**AGENDA**  
Regular Hybrid Meeting  
Town of Granby  
Inland Wetlands and Watercourses Commission  
Wednesday, April 9, 2025, at 7:00 pm  
Town Hall Meeting Room

**MEETING MINUTES**  
Town of Granby  
Inland Wetlands and Watercourses Commission  
Wednesday, March 12, 2025, at 7:00 pm

**RE: 188 Day Street Plans**

Re: Review of March 28, 2025 Brook Crossing Plan and Alternatives Analysis Statement  
15 Peck Orchard Road, Granby, CT  
JE Project No. 21-29

GR-1

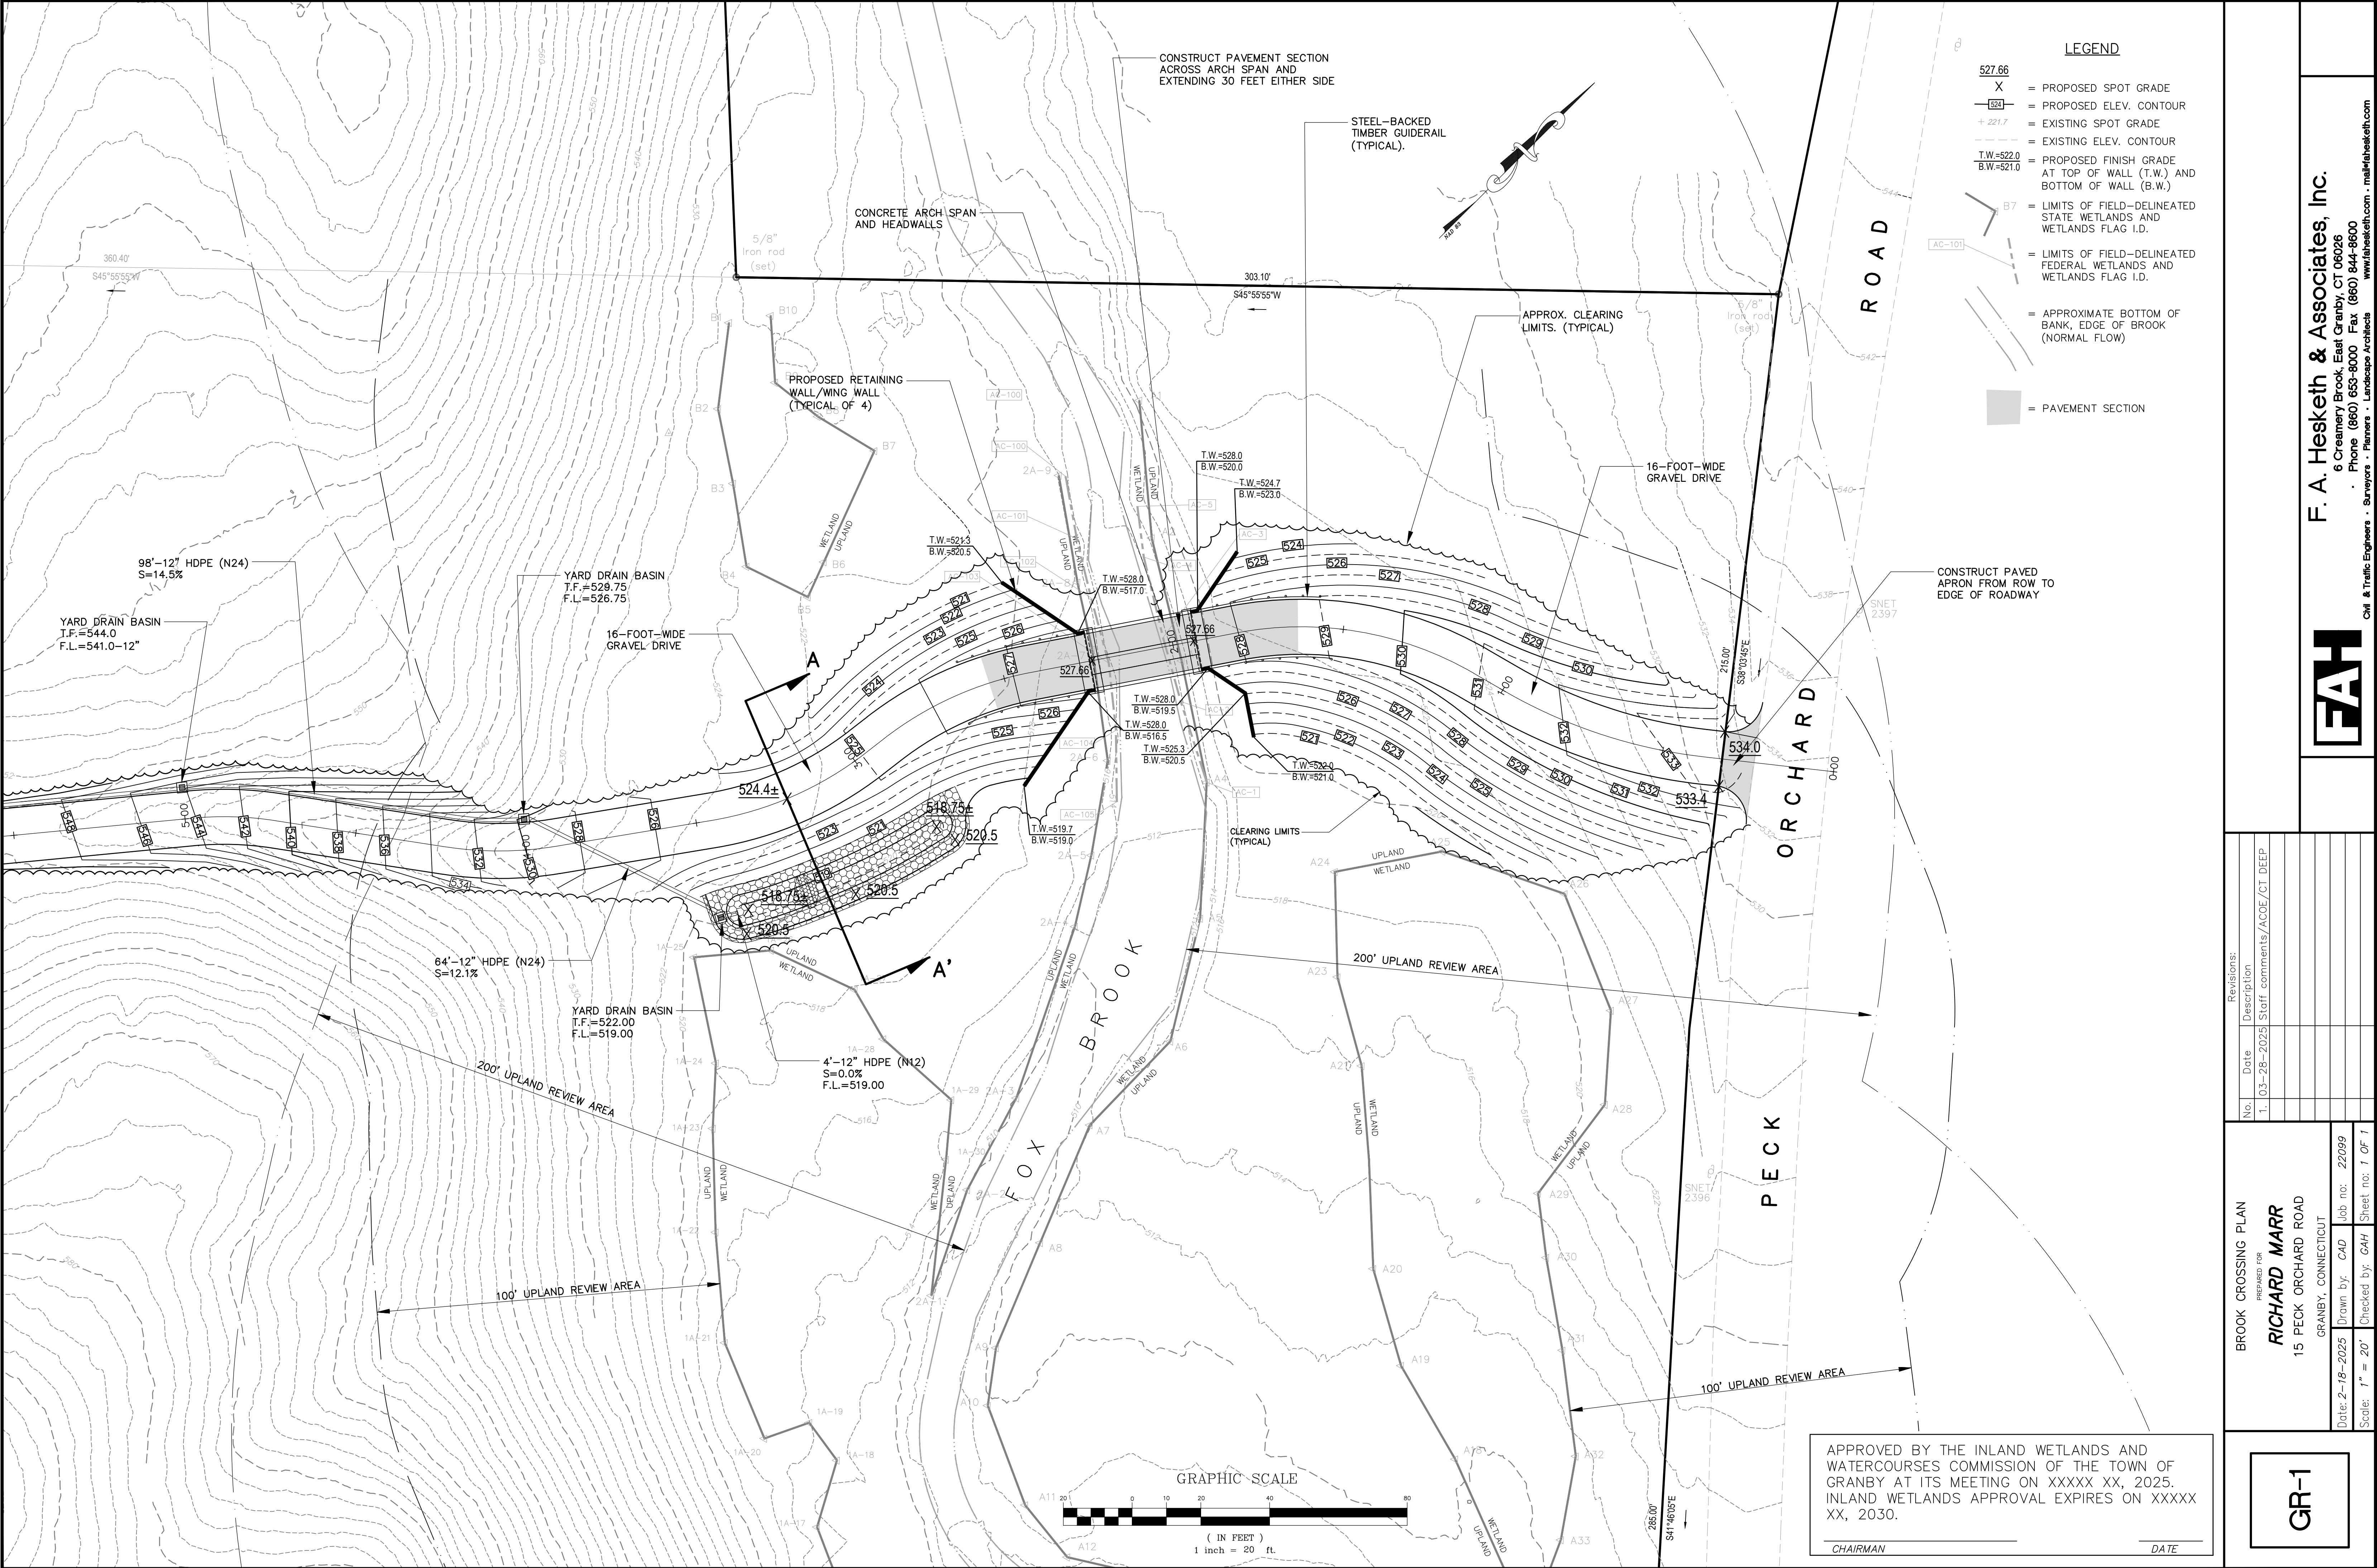
Per your request, Jackson Environmental has reviewed the March 28, 2025 (Rev.) Brook Crossing Plan, and the April 4, 2025 Alternatives Analysis Statement for the proposed Brook Crossing and Driveway Construction, prepared by F.A. Hesketh & Associates, Inc.

The proposed Soil Erosion and Sediment Controls, shown on Plan Sheets EC-1 and EC-2, and the General Erosion and Sediment Control Notes and Erosion Control Devices (Sheet NT-1) are adequate and conform with protocols contained in the 2024 Connecticut Guidelines for Soil Erosion and Sediment Control.<sup>1</sup> The proposed Soil Erosion and Sediment Controls within the Brook Crossing Plan are protective of the inland wetlands and the Fox Brook watercourse shown in the Crossing Plan.
